**Design Review Board  
Regular Meeting**

**Tuesday, May 17, 2022, 7:00 P.M.  
AGENDA**

## REPORT TO DESIGN REVIEW BOARD

**SUBJECT: Northgate Town Square Project.** Requests for a Rezone to the Planned Development (PD) zone, a Use Permit, an Environmental and Design Review Permit, and a Tentative Map to allow the comprehensive redevelopment of the existing mall at 5800 Northgate Drive into a new, phased mixed-use development with approximately 225,000 square feet of retail and 1,441 residential units on a 44.76-acre site. APNs: 175-060-12, -40, -59, -61, -66 & -67; General Commercial (GC) District; MeloneGeier Partners, owner/applicant.

Figure 7 – View of Residential 3 Townhomes

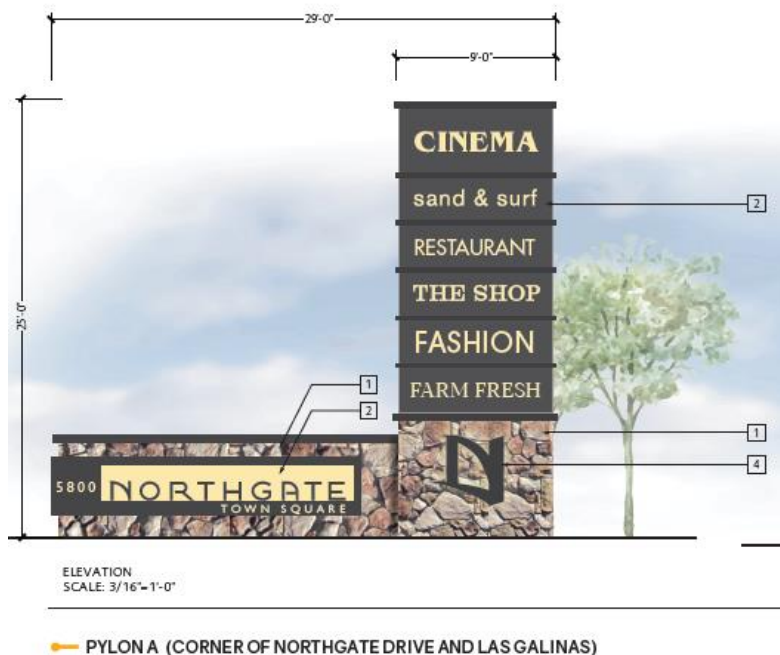
This view shows the proposed three-story townhomes looking northerly from Northgate Drive, showing the massing from the residential areas to the south.
